Artform Home Plans
AFHP Design # 410.120.v2 KR
© 2012-2014 Wendy Welton 603.431.9559

Great Scott Cape
15 Lorden Commons
Londonderry, NH

Issued for:
Construction

R1: 2.26.2014 - Minor interior changes to first floor

Front Elevation

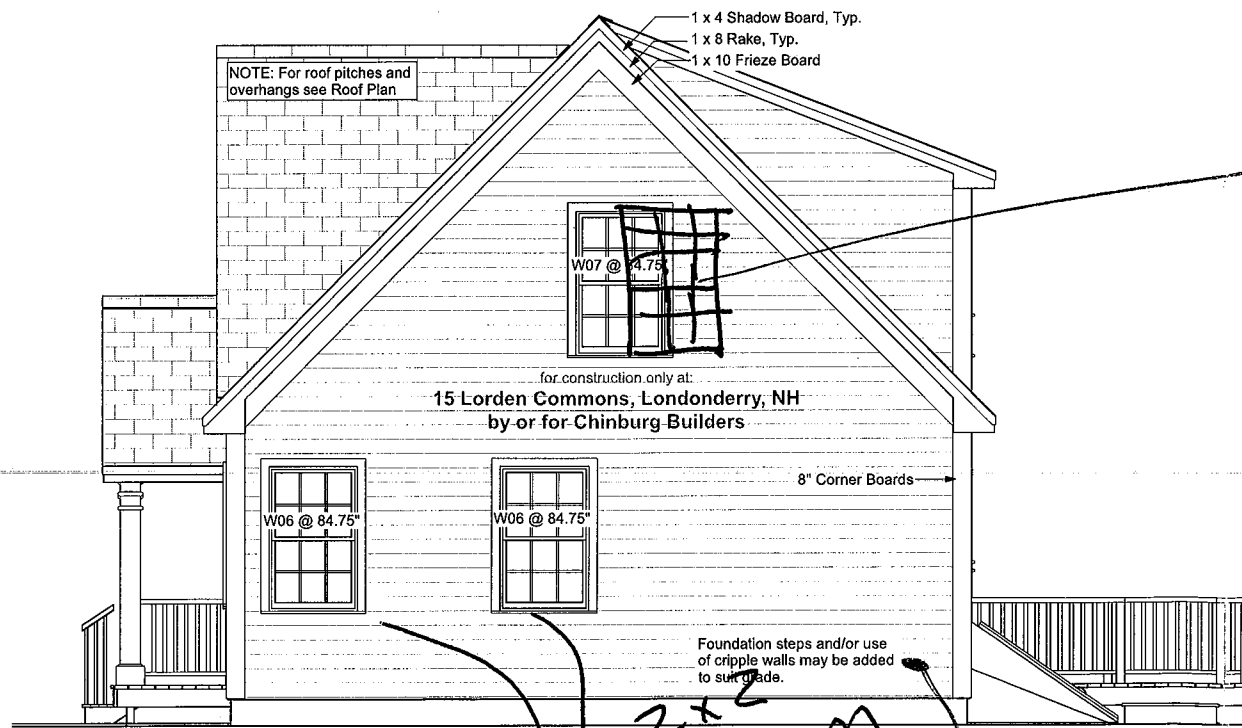
MOVE AS FAR AS POSSIBLE

2x2 Transom windows

H2O

Rear Elevation

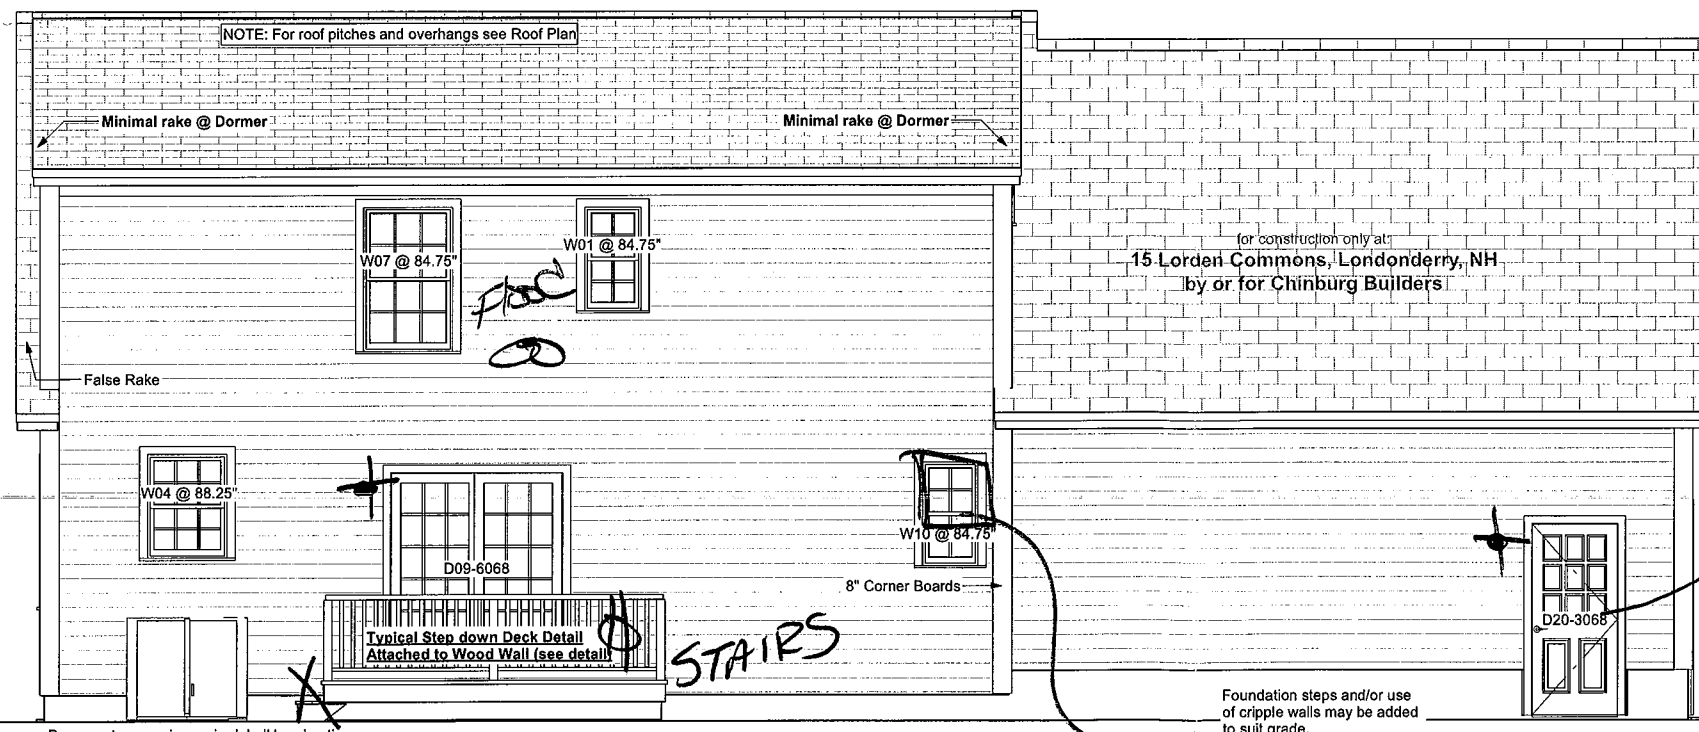
move door TO side

change TO 2+2 Awning
